Declaration of changes

Differences between the items				Note
Model Name	TA-1448	N1530DL	TA-1476	
GSM:	850, 900, 1800, 1900	850, 900, 1800, 1900	850, 900, 1800, 1900	1、PCB is the same, PCBA is different; Because of the different frequency band, part of the inductance capacitance is also different; and the performance of the same frequency band is not affected 2、N1530DL product is the same as TA-1476 except for the model name.
3G UMTS (WCDMA)	B1,B 2,B 4, B5,	B2, B4, B5	B2, B4, B5	
LTE Bands:	B1, B2, B3, B4, B5, B7, B8, B12, B13, B17, B20, B25, B26, B38, B39, B40, B41, B66, B71	B2, B4, B5, B12, B13, B25, B26, B41,B66, B71	B2, B4, B5, B12, B13, B25, B26, B41 B66, B71	
NR bands	n71, n66, n25, n41,n77	n2, n5, n66, n77, n71, n25, n41	n2, n5, n66, n77, n71, n25, n41

The different components locations are as below

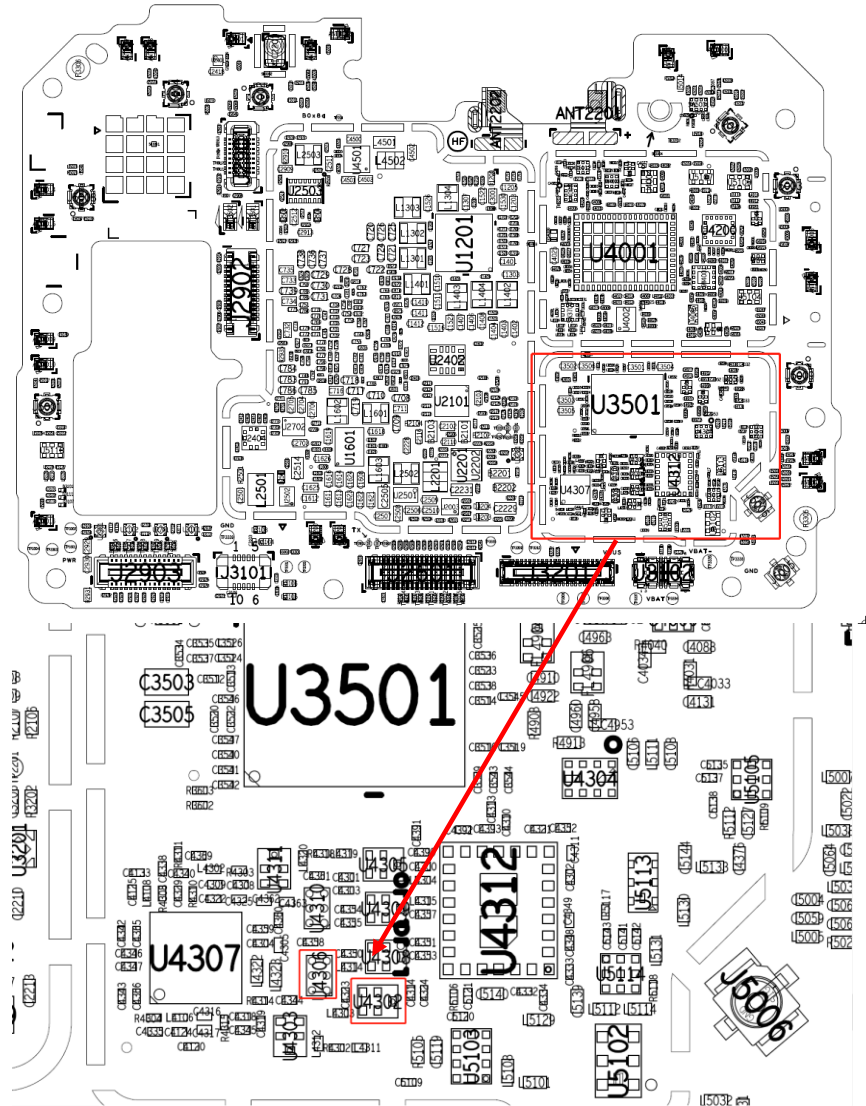
2AJOTTA-1448 :have the components U4302 and U4306; 2AJOTTA-1530and 2AJOTTA-1476: not have the components U4302 and U4306 ; the other components of the three SKUs are same;

1.N1530DL and TA1448 share a PCB and there is a difference on the frequency band, hence U4302/U4306 Band20 related items will be removed from BOM, U4302 is saw for B20, U4306 is swith for B20, Does not affect rf performance except for B20

2.LTE B7/17/38/39/40Related devices are integrated in the IC, so it can only be turned off from the software

3.In order not to affect the integrity of the drawing, N1530DL,TA1448 difference frequency band is not differentiated in SCH So to illustrate
